Staff Report

File #: LN-659

PLANING AND ZONING BOARD
Meeting Date: NOVEMBER 20, 2024

Text Amendment to Zoning Code related to the height and location of Gazebos/Tikis/Chickees and the required Rear Yard Corner Triangle

Figure 155.5302.D.5.a: Rear yard corner triangle

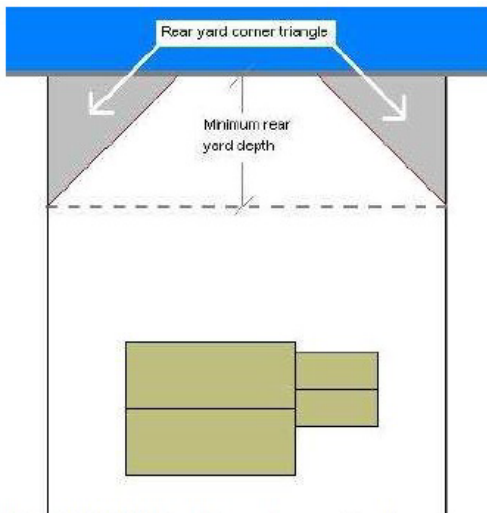
~~a. Within Rear Yard Corner Triangle~~

~~—Except as otherwise provided in subsection e below, where the rear lot line abuts the canal or waterway, no fence, wall, or other obstruction greater than three feet high shall be located within the triangular land area formed by the intersection of the rear lot line with an interior side lot line not abutting a canal or waterway— with two sides of the triangle running along the rear and interior lot lines and being equal in length to the minimum rear yard depth, and the third side being a line connecting the ends of the other two sides—provided that a fence in such area may be as high as 42 inches if it is 66 percent see-through and may be as high as six feet if it is at least 75 percent see-through. (See Figure 155.5302.D.5.a: Rear yard corner triangle.)~~

Staff proposes to eliminate all rear yard corner triangle standards (remove fence and vegetation transparency, no structures or obstructions over 3 feet in height) and to create an exemption for Gazebos/Tikis/Chickees to allow them within 3 feet of a rear lot line abutting a waterway or canal. Such structures are already permitted within 3 feet of an interior side lot line when a six-foot-high solid fence exists; otherwise, a 5-foot setback is required. The overhang of the Gazebo/Tiki/Chickee roof shall not be permitted within 1 foot of the interior side setback. This way, there is no scenario where the roof of the structure is 0 feet from the shared property line. Additionally, Staff proposes to modify the maximum height of the structure to 15 feet rather than the 10 feet that is required for a Gazebo or Tiki. A true chickee hut can have a height of 15 ft. But as is often the case, a chickee “becomes” a tiki over time when plumbing, electrical and/or other non-native materials are added. In such cases, the height is then required to be reduced to 10 feet, creating additional code compliance issues. Therefore, a uniform height requirement of 15 feet is proposed.

- Remove this section, references, and renumber
